**Public Hearing on Planned Unit Development
Rezoning and Site Plan—Restaurant
Depot—JRD Real Estate VI, LLC**

CITY OF LA VISTA
PLANNING DIVISION
RECOMMENDATION REPORT

CASE NUMBER: PPUD-17-0002

RE: Planned Unit Development (PUD) Rezoning and Site Plan – Initial Review
Lot 2 Harrison Hills
Restaurant Depot

DATE
JOB NO. 16356
EMERGENCY VEHICLE TURNING
SHEET NO.

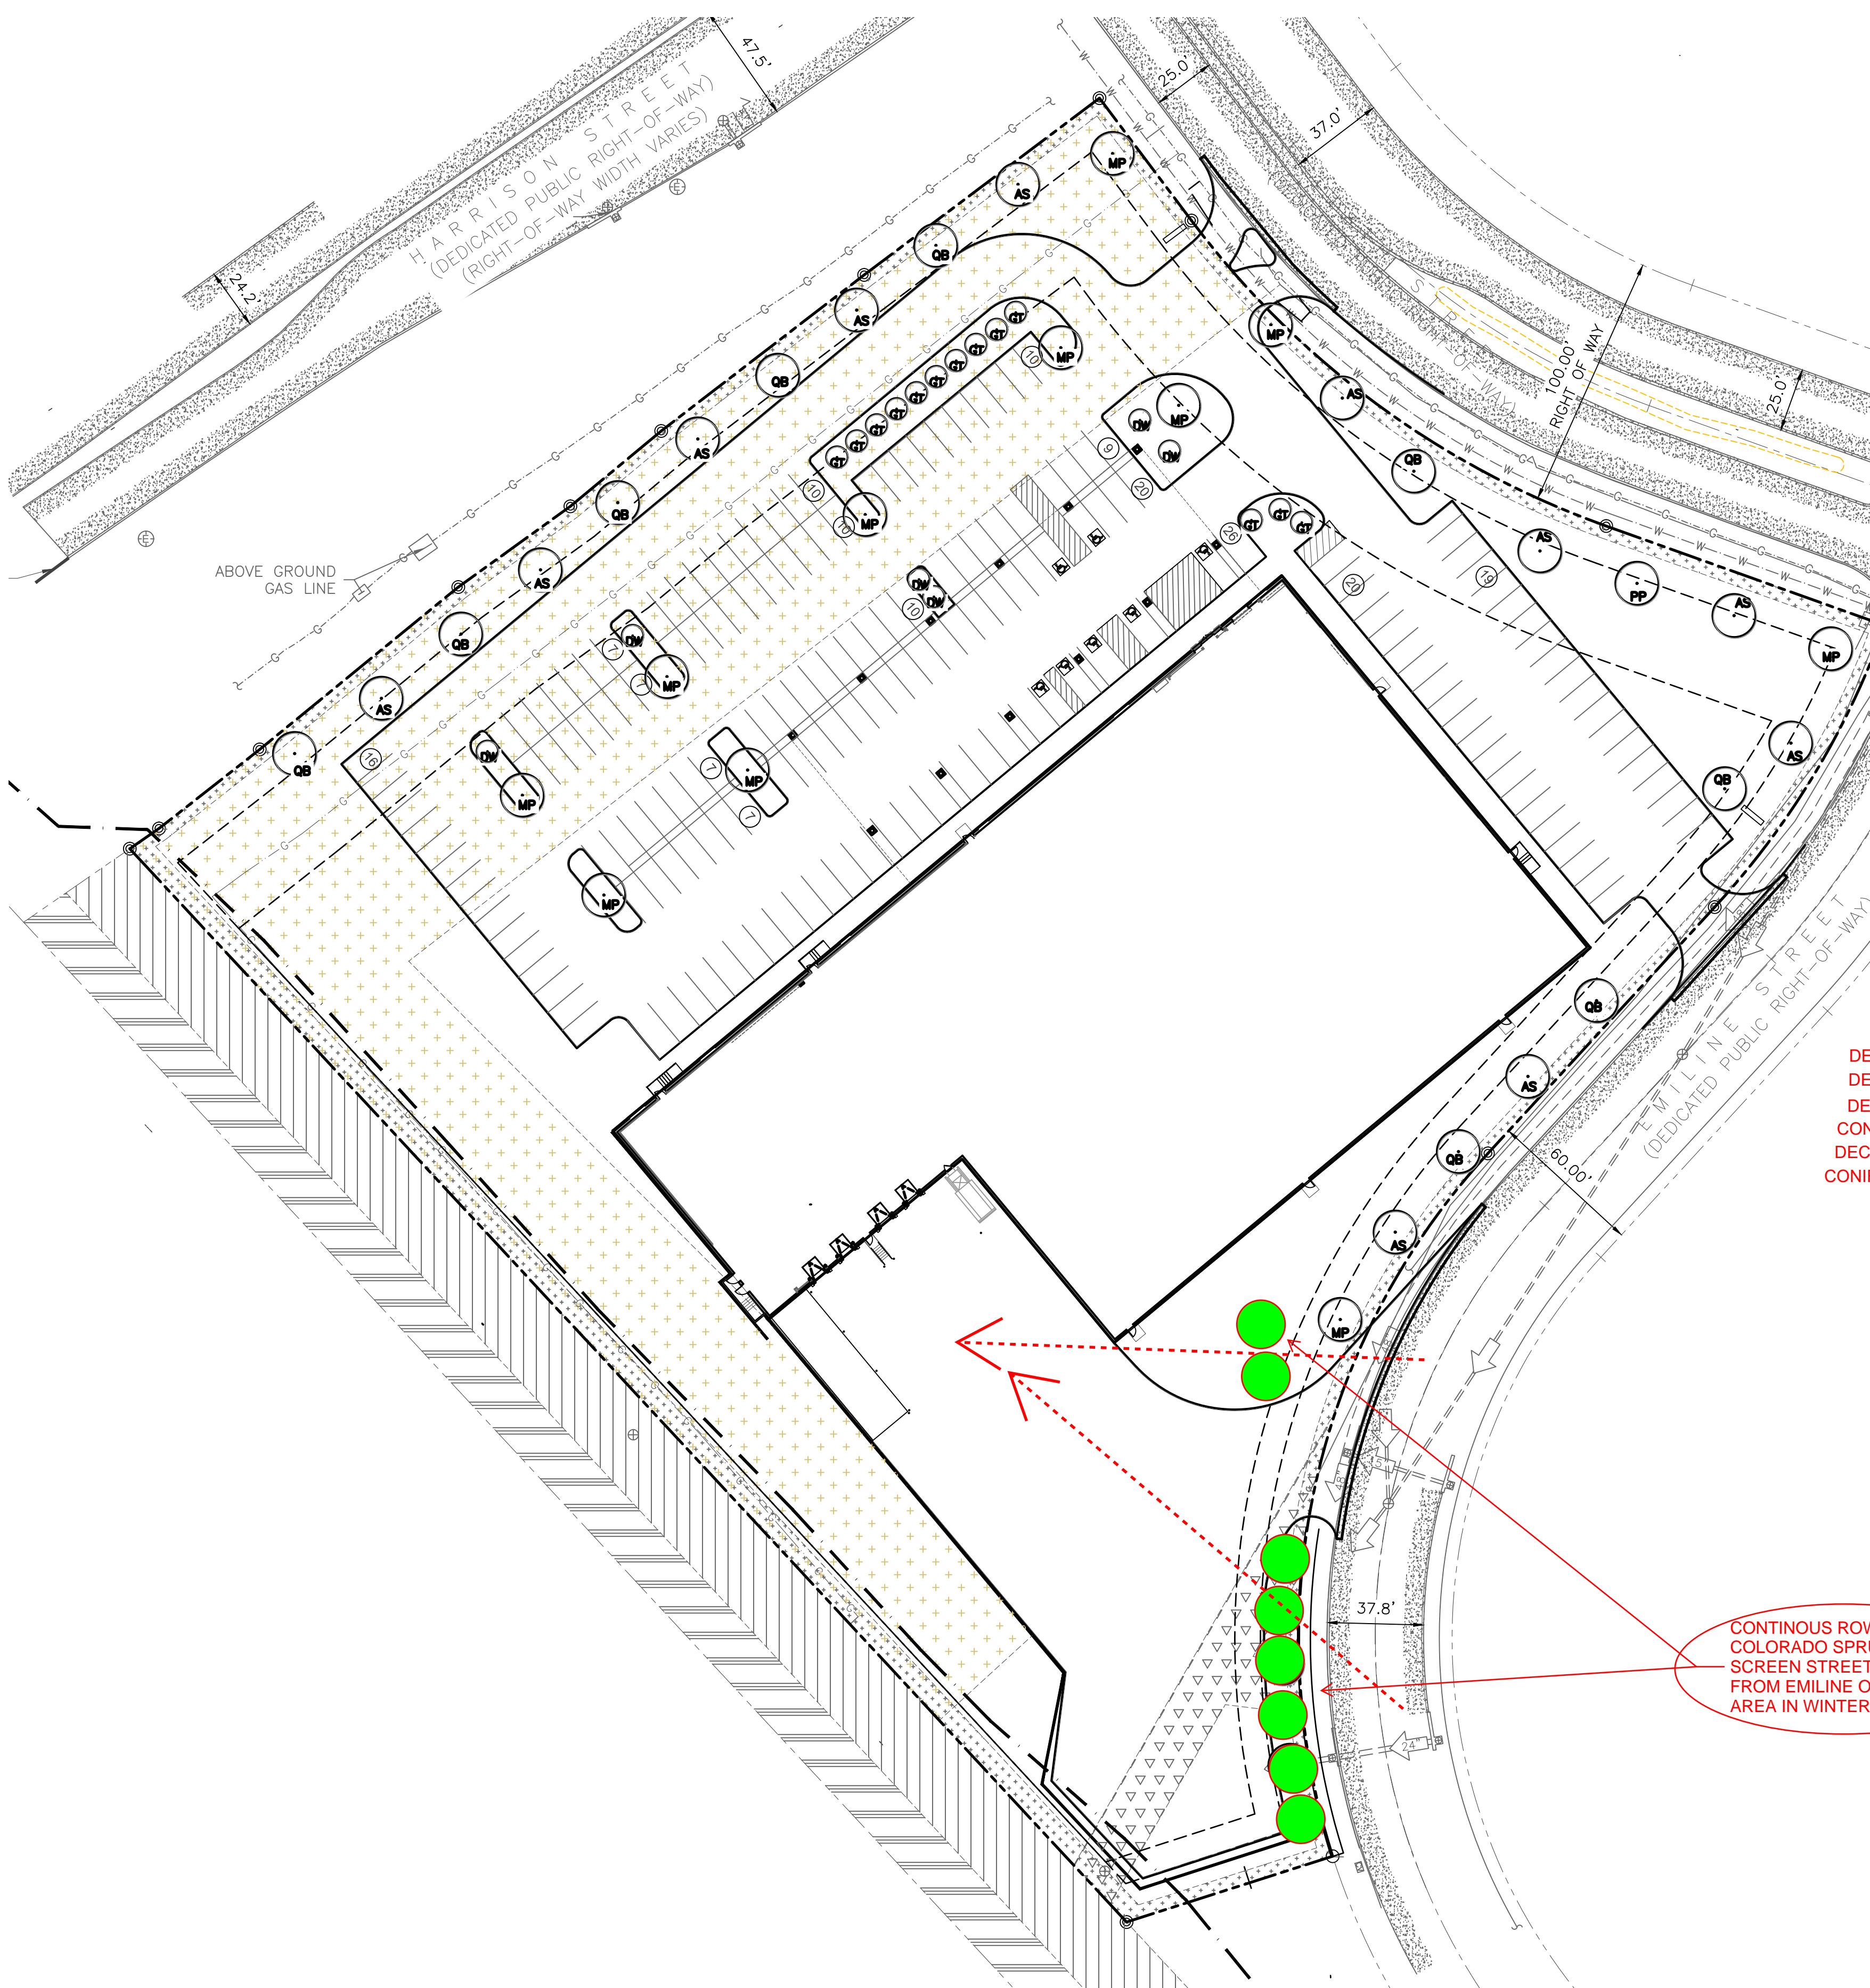
9. The call-out for the equipment screening wall on the Emergency Vehicle Turning plan is pointing to the wrong location.
10. The Papillion Fire Marshal's office has prepared a memo regarding the Emergency Vehicle Turning plan. It is attached for your review.

After having reviewed the Restaurant Depot plan set I am not satisfied with the depiction rendered for the emergency vehicle turning radii. The path they show does not even approach the building. It appears to me that the large island just inside of the 118th St. entrance will pose a problem for apparatus access, especially if cars are parked in the lot.

10. Fire Marshals' Review Letter – We have adjusted the Vehicle Turning Plan to show the path through the site allowing access approaching the buildings.

DATE
JOB NO. 16356
LANDSCAPING
PLAN
SHEET NO.

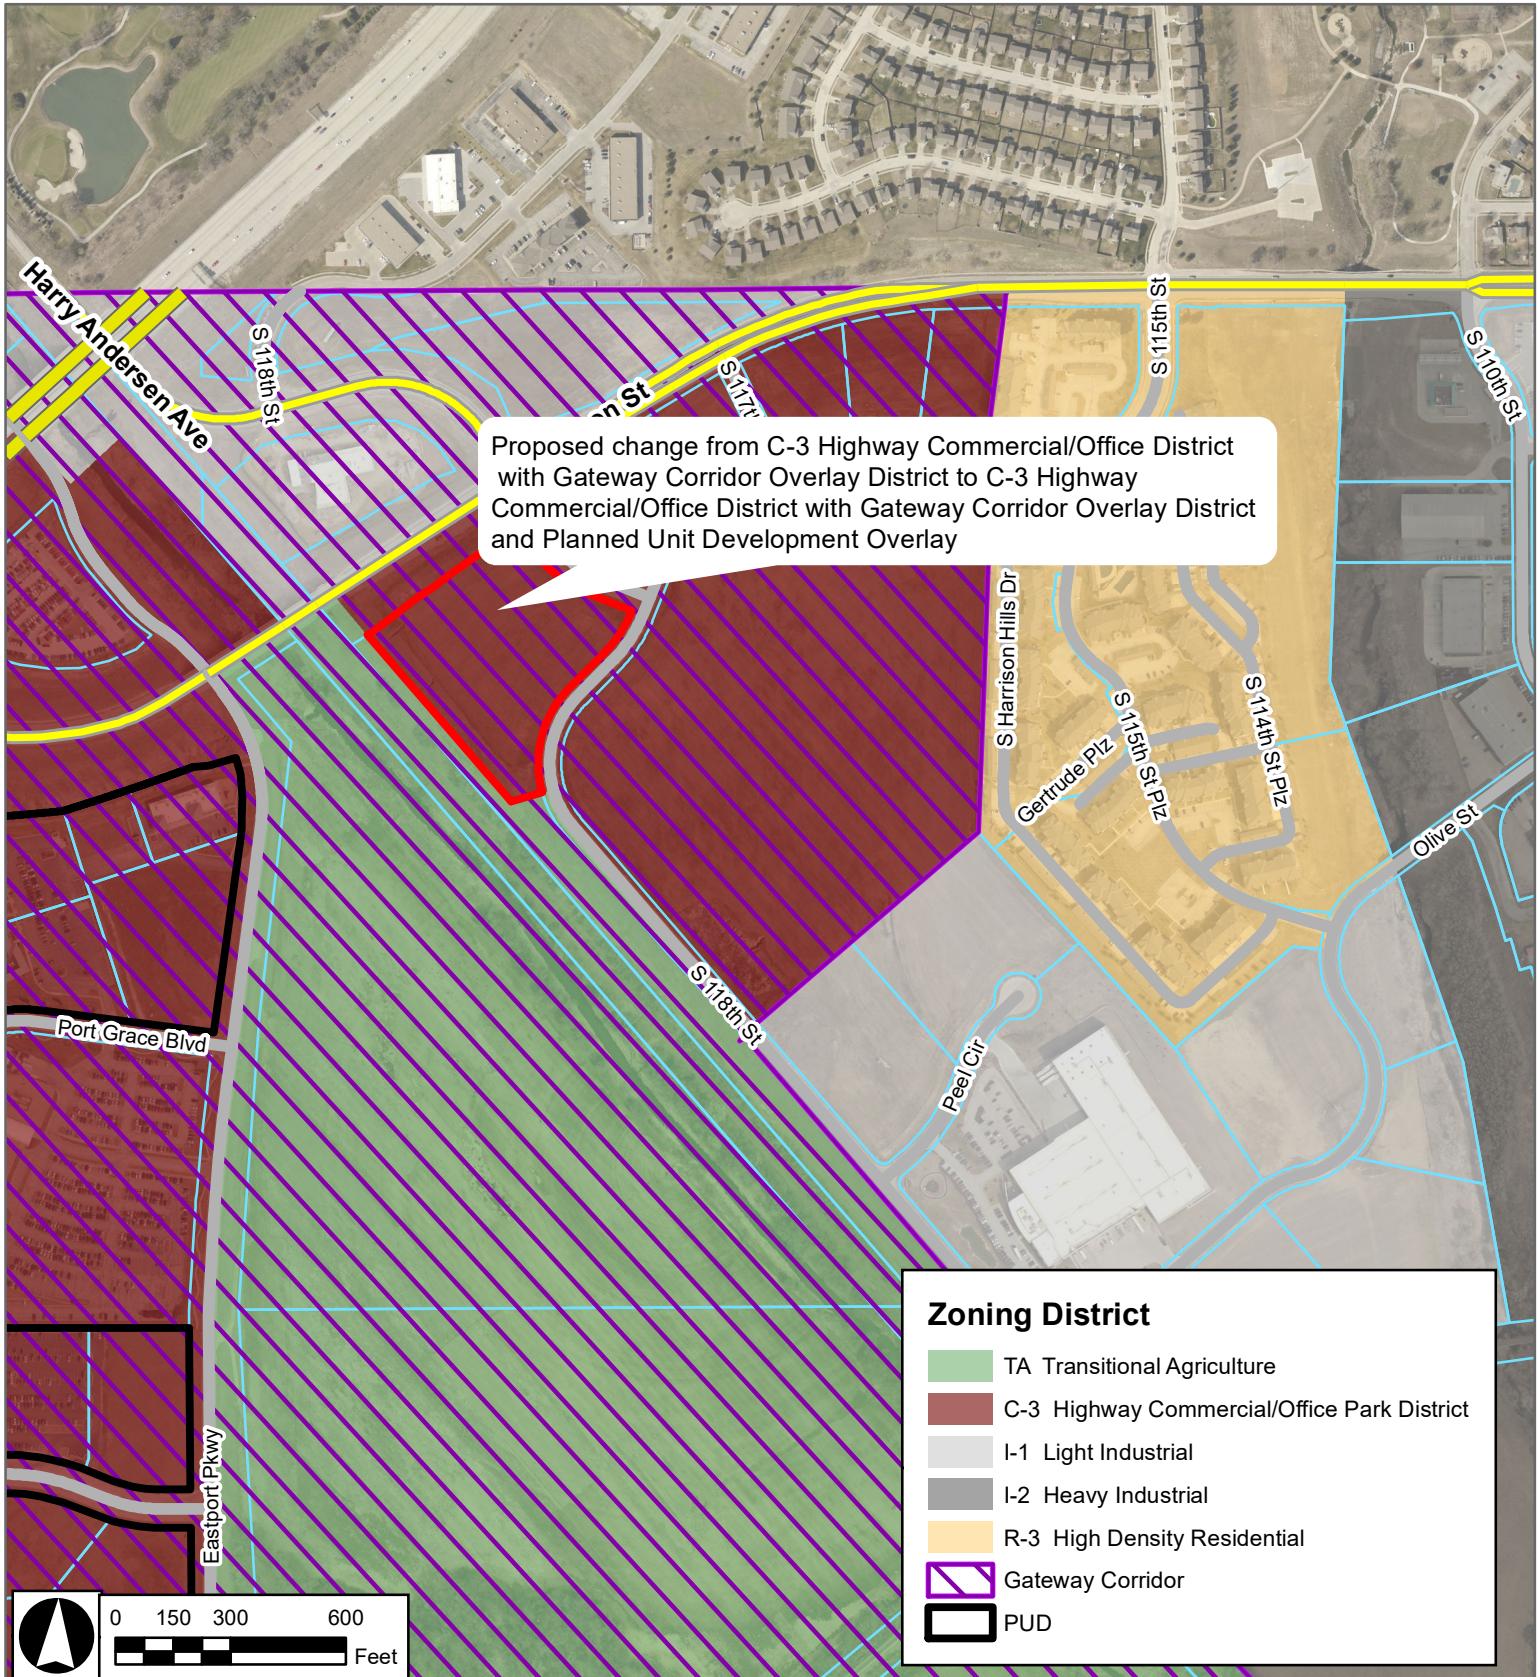
11. The landscaping plan needs a note added about irrigation as per Article 5.17.05.03.
12. The landscaping plan has been provided to the City's Design Review Architect for review. Additional comments, if necessary, will be provided upon completion of his review.

11. Irrigation – The Landscape Drawing(s) have been revised to add the notes for irrigation.
12. Landscape Plan – We have updated the landscape plan and included it in the resubmittal.
13. TIS Review – As noted in Item 2 above, we have changed the entrance to Right-In only.
14. Left Turn Phasing Warrant – Acknowledged.
